# **RANCHO SANTIAGO COMMUNITY COLLEGE DISTRICT**

## **ADDENDUM NO. 03**

**Bid #1456 CAMPUS ENTRANCE IMPROVEMENTS PROJECT  
at  
SANTA ANA COLLEGE**

## DSA ADDENDUM NO: 01 & 02

**POWER AND LIGHTING PLANS**

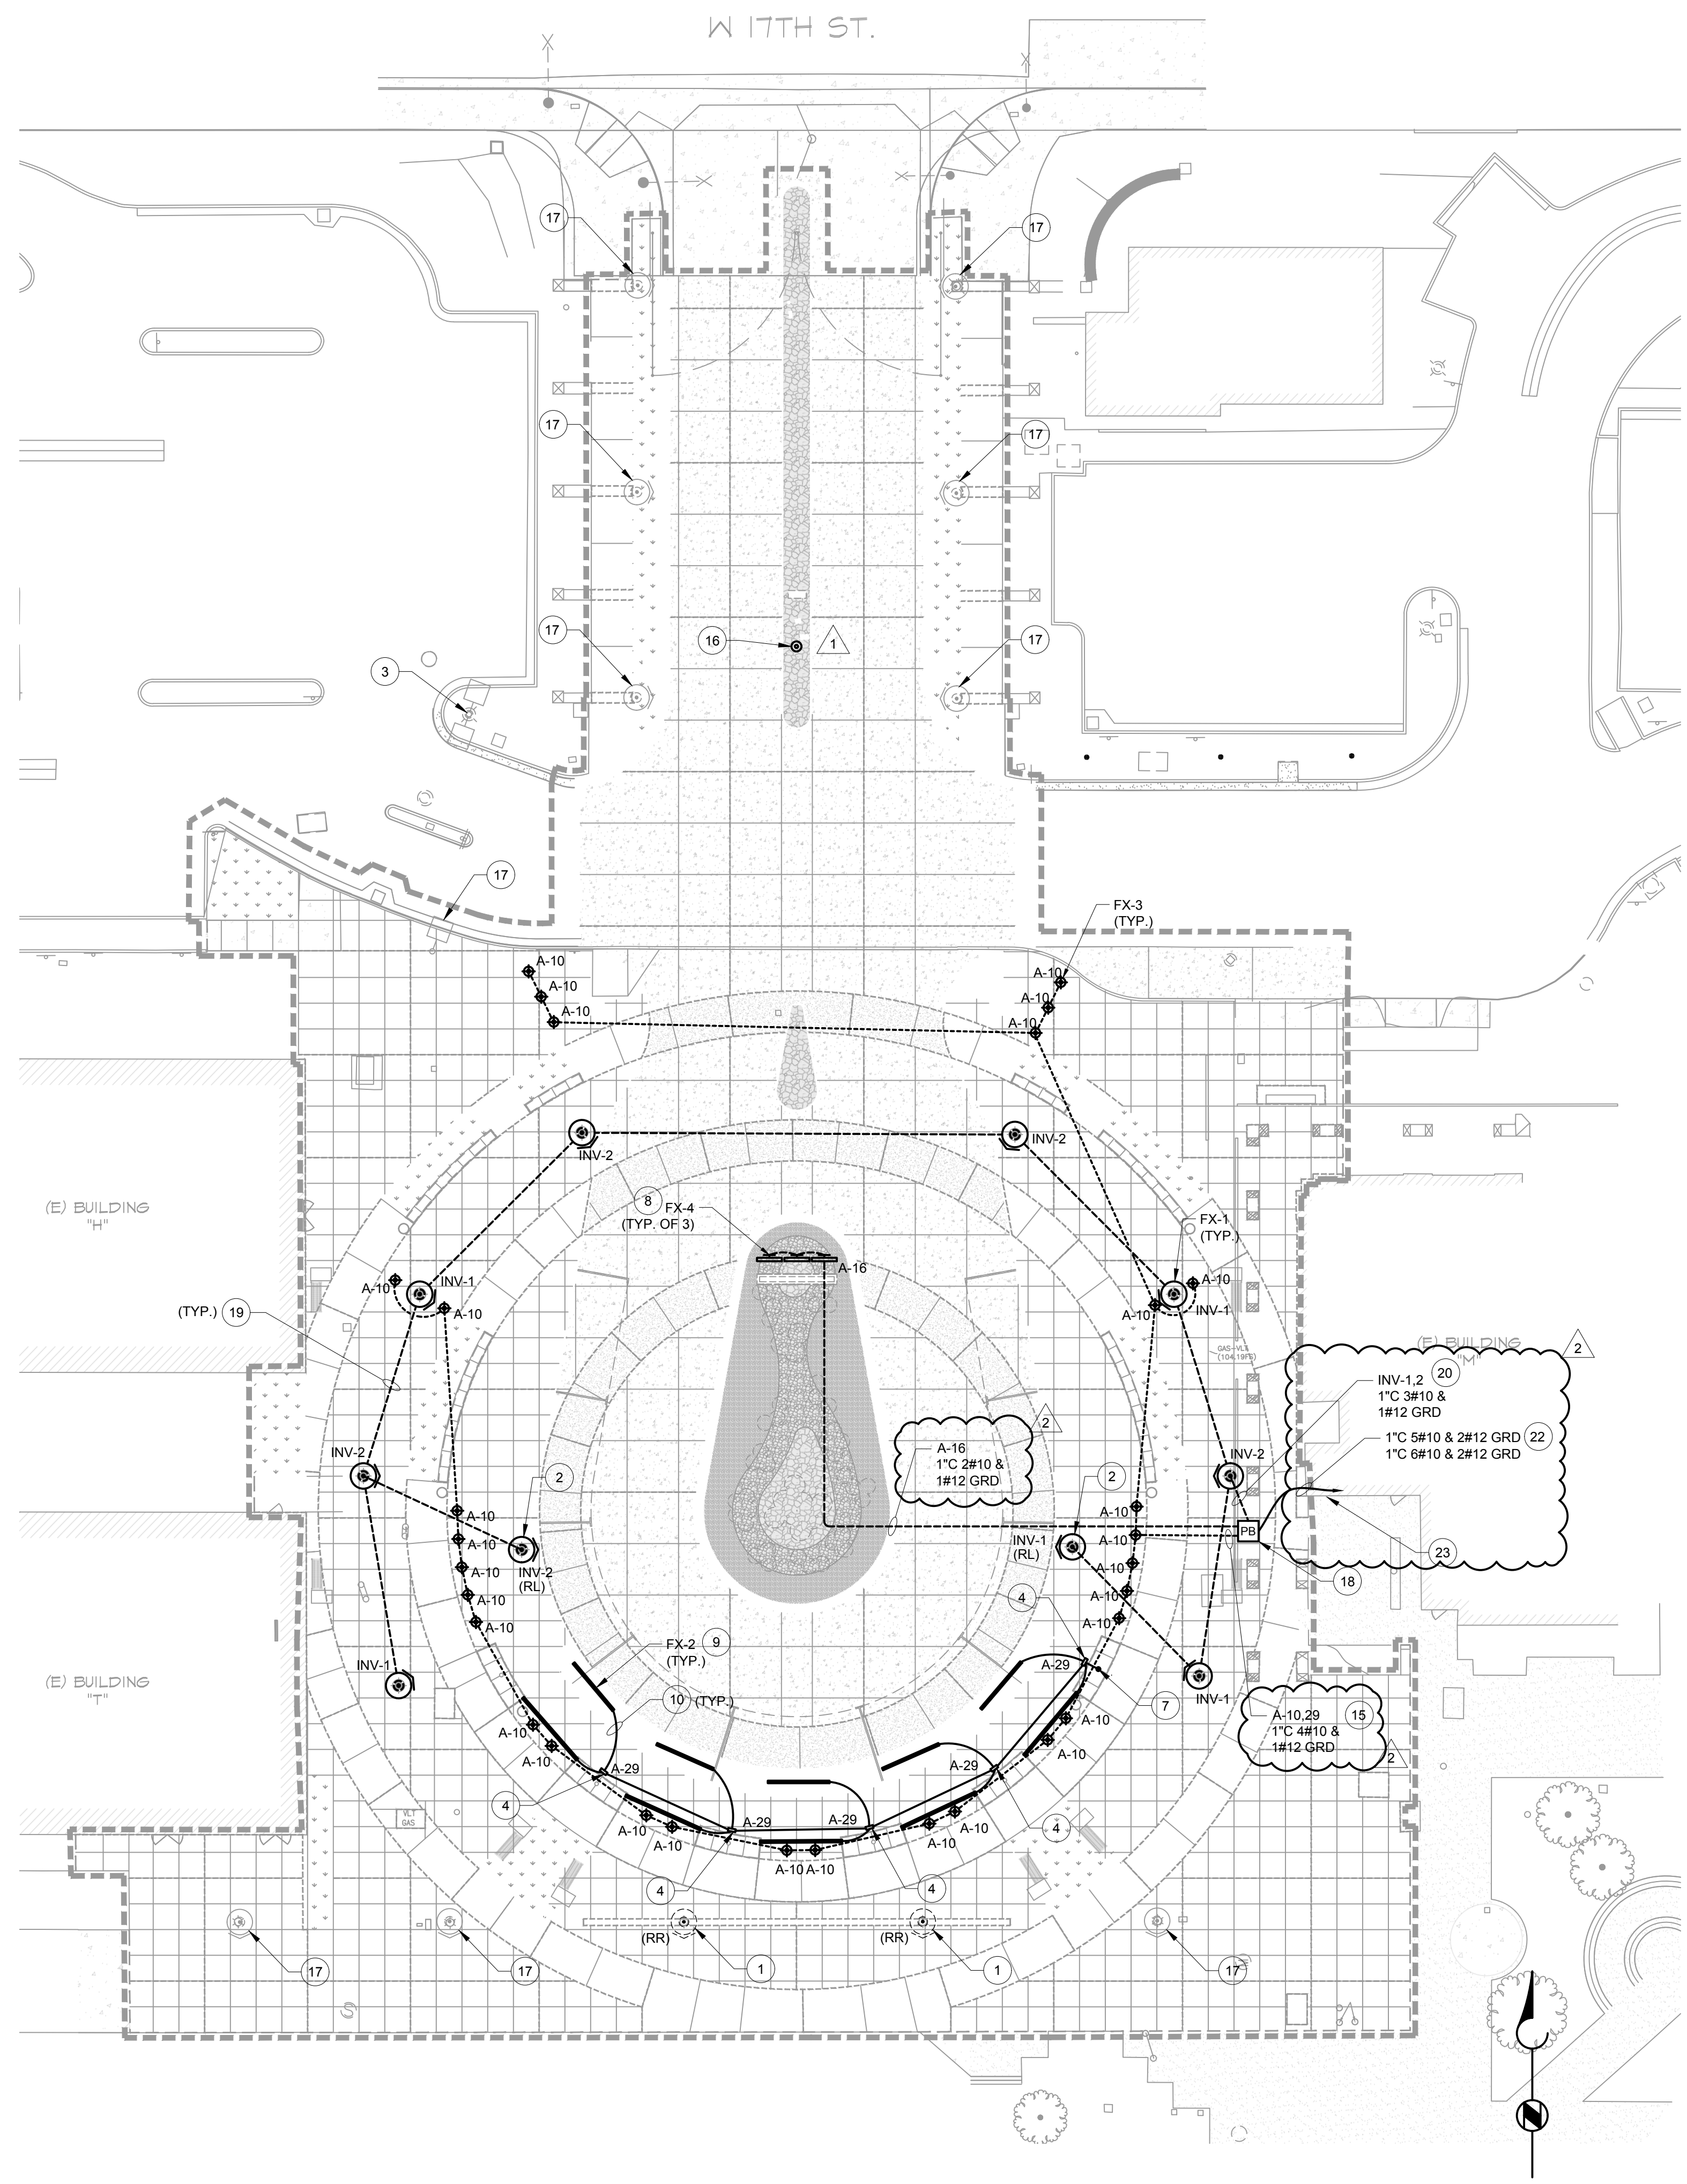
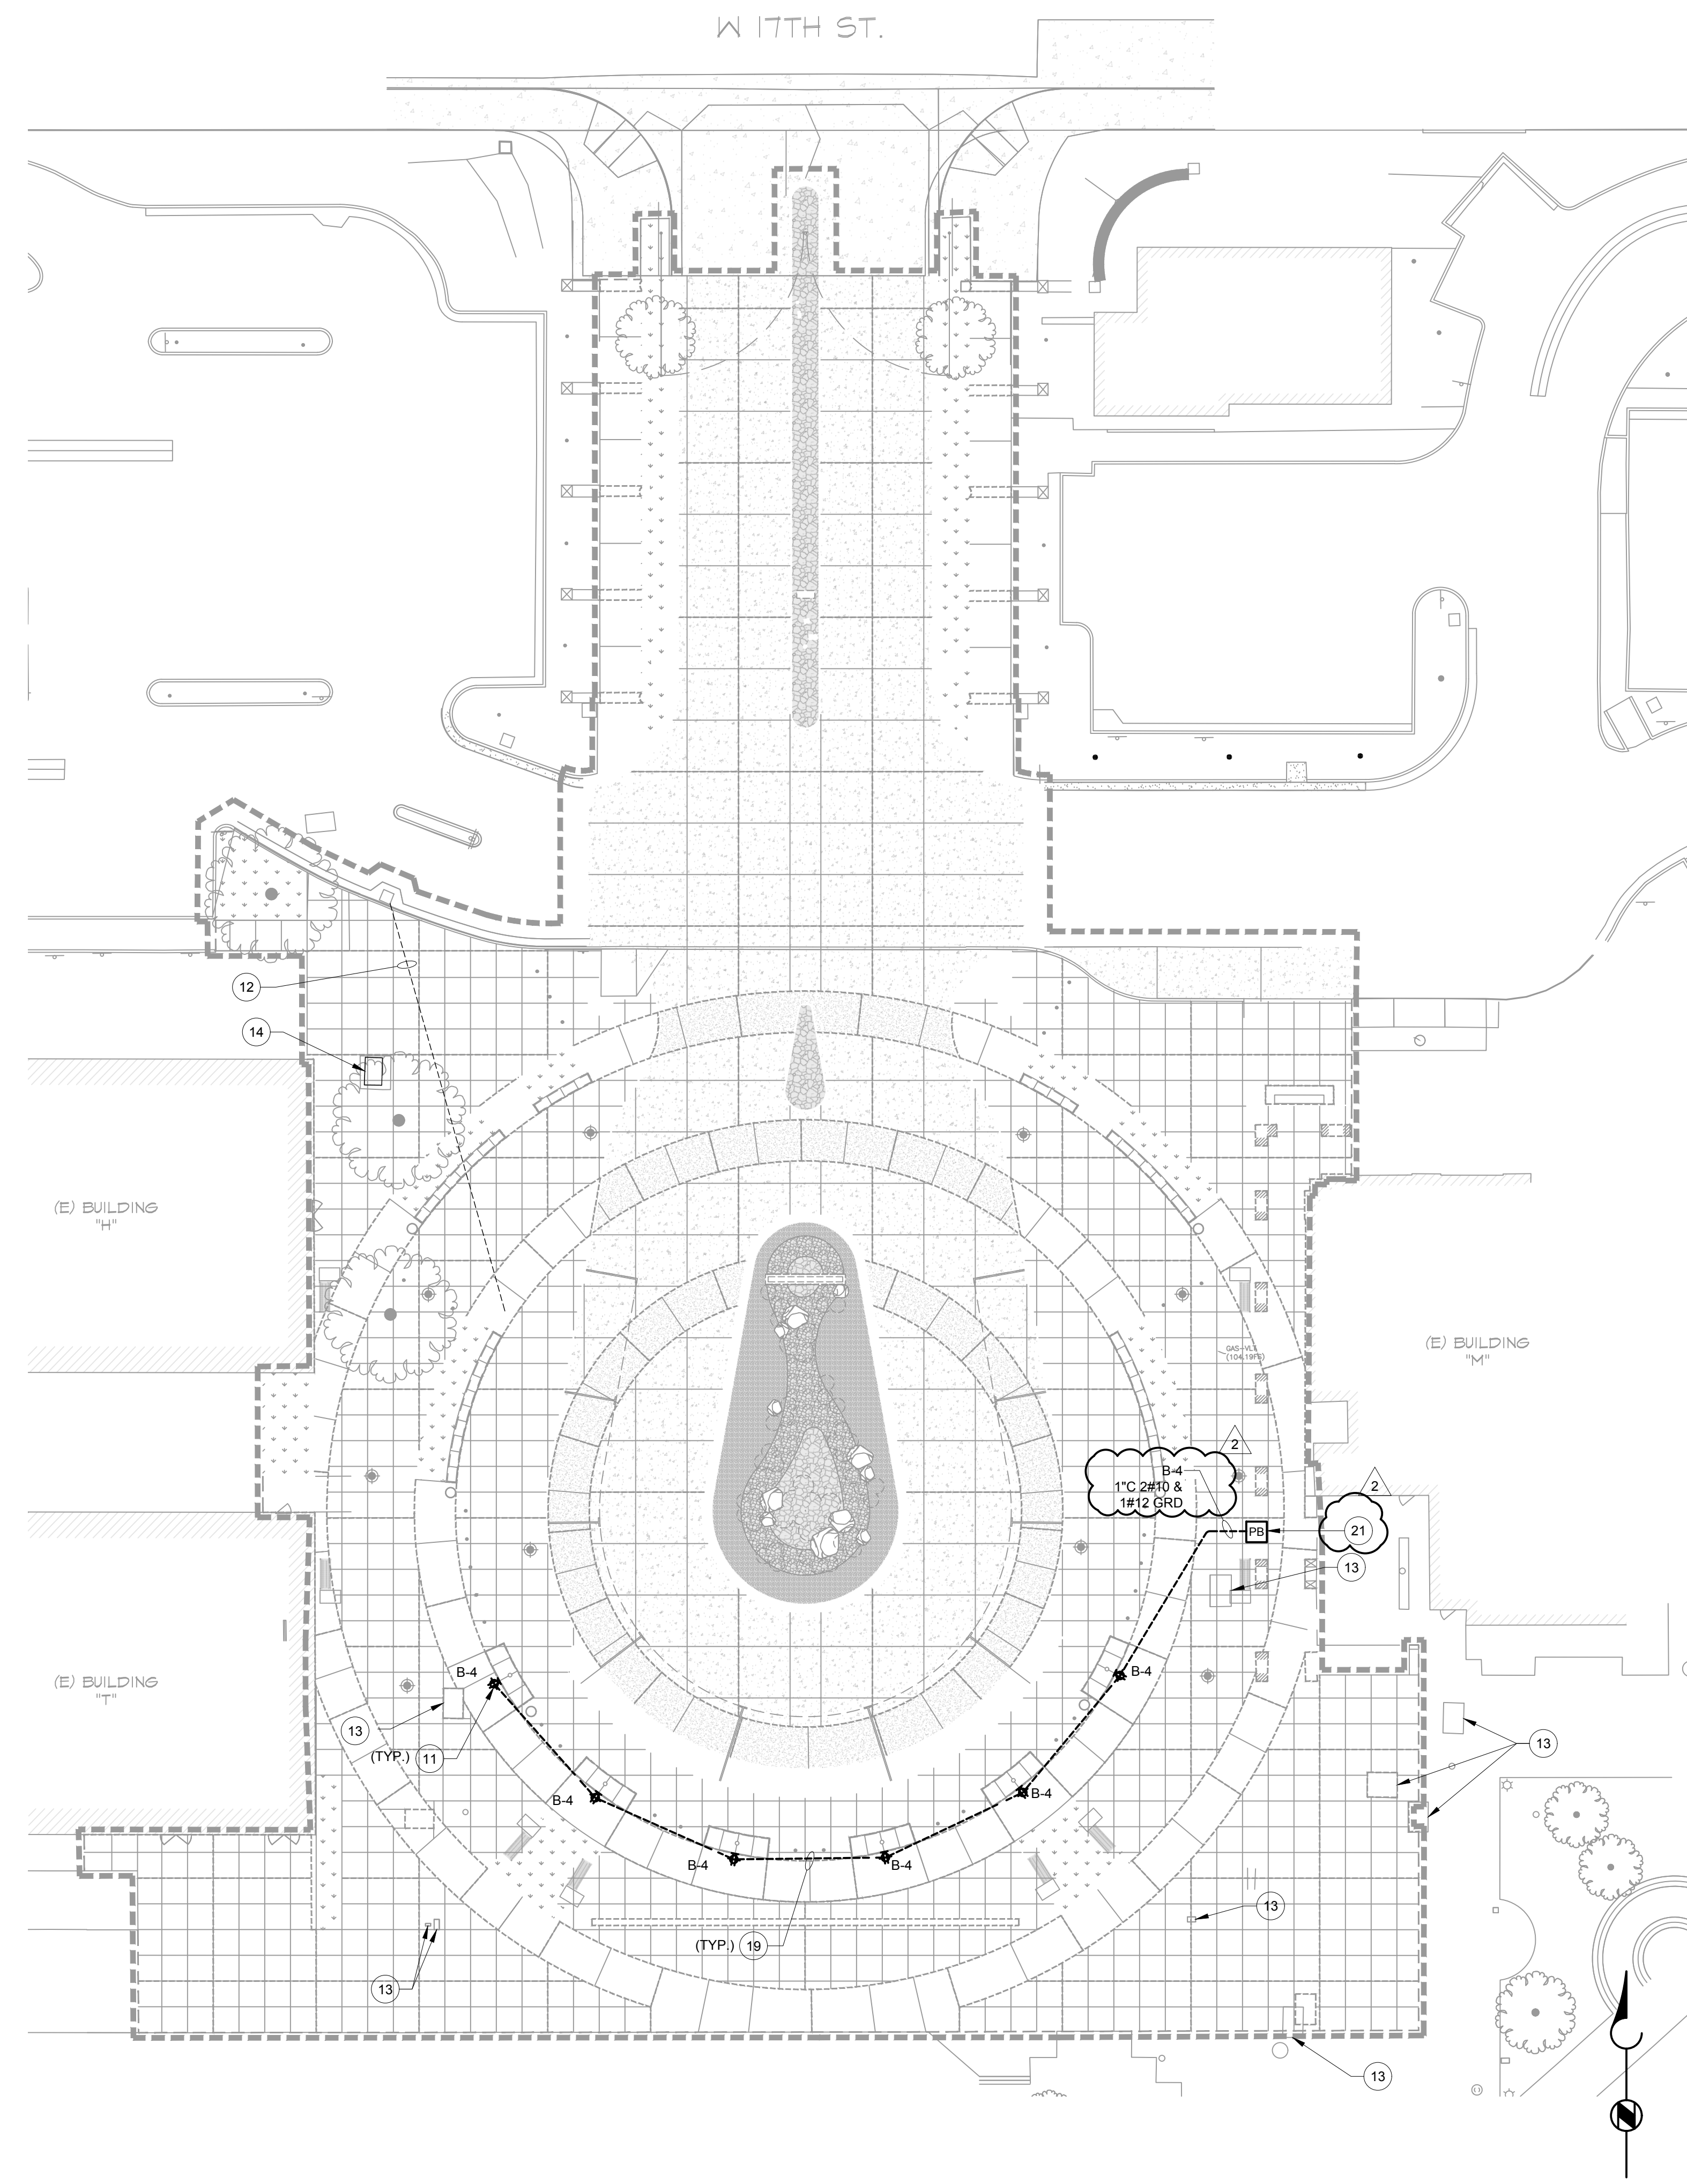
- A. E-1.2, Power and Lighting Plans: Revised reconstruction keynote #16, to provide referenced detail of a new concrete base: *“Camera and pole to be removed and stored during construction of concrete walkway/median for protection. Footing to be removed, provide new footing during reinstallation. See detail 1/E1.3 for camera pole base detail.”* Located the concrete base for the pole and camera on the lighting plan, 1/E-1.2.
- B. E-1.3, Photometric Plans: Added new camera pole base detail 1/ E-1.3 on left side of sheet. The new concrete base detail to install the existing pole and camera will be in the new median at the drive aisle near the vehicular entrance / exist.

- A. E-1.2, Power and Lighting Plans: Revised reconstruction keynote #15, to now state: *“Provide a separate neutral for circuit A-10.”* Added the keynote on the southwest corner of Building “M” of the lighting plan, 1/E-1.2.

- B. E-1.2, Power and Lighting Plans: Added new reconstruction keynote #21, to indicate: *“See pull box on lighting plan.”* Added the keynote on the west side of Building “M” of the power plan, 2/E-1.2.

- C. E-1.2, Power and Lighting Plans: Added new reconstruction keynote #22, to indicate: *“Combine all wiring for panel ‘A’. into (1) 1” conduit. Combine all wiring for inverter and panel ‘B’ (see power plan) into (1) 1” conduit.”* Added the keynote on the west side of Building “M” of the lighting plan, 1/E-1.2.

- D. E-1.2, Power and Lighting Plans: Added new reconstruction keynote #23, to indicate: *“Enter Building M on southeast corner, stub up into 8X6 surface mounted pull box and stub in above Building M, curb into building wall. Run conduit and wiring inside wall into ceiling space and route conduit and wiring back to Electrical Room. Provide framing and plaster to match existing exterior around exposed conduit to hide electrical conduit.”* Added the keynote on the west side of Building “M” of the lighting plan, 1/E-1.2.

- E. E-1.2, Power and Lighting Plans: Added a note to provide information on the type and size of the conduit running from the center median at the pick-up/drop-off area to the new pull box adjacent to Building “M”. Added the note between the center media of the pick-up/drop-off area and Building “M” of the lighting plan, 1/E-1.2.

- F. E-1.2, Power and Lighting Plans: Relocated the location of keynote #20’s leader, which is now pointing at the conduit between a light pole fixture and new pull box. The keynote is located west of Building “M” of the lighting plan, 1/E-1.2.

- G. E-1.2, Power and Lighting Plans: Relocated the location of the note on the type and size of the conduit of B-4, which is now pointing at the conduit on the west side of the new pull box. The keynote is located west of Building “M” of the power plan, 2/E-1.2.
